ADDENDUM NO. 2

RE: Sewer Transfer Project

SEWER TRANSFER PROJECT
TOWN OF PALISADE
GRAVITY LINE TRACER WIRE

SK01

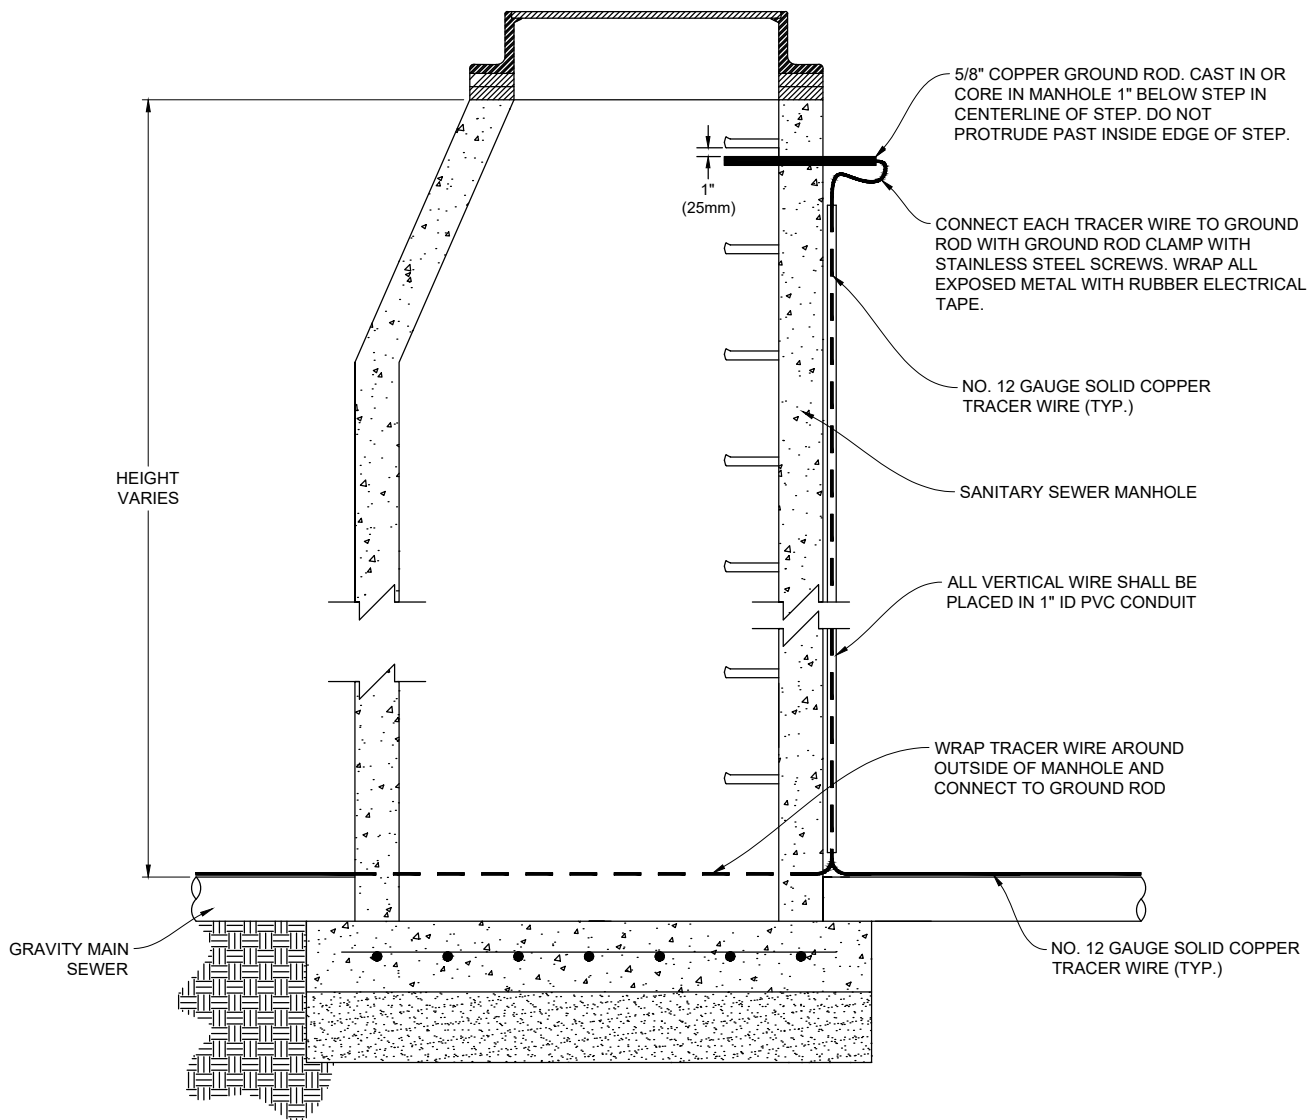
2. Question: "Will tracer wire be required for the gravity sewer lines?"

Response: Tracer wire will be required for installation along the gravity sewer lines. The attached sketch SK01 provides the required tracer wire detail for installation and connecting this wire from manhole to manhole. All costs associated with the purchase and installation of this tracer wire is incidental to the cost of the gravity sewer pipe.
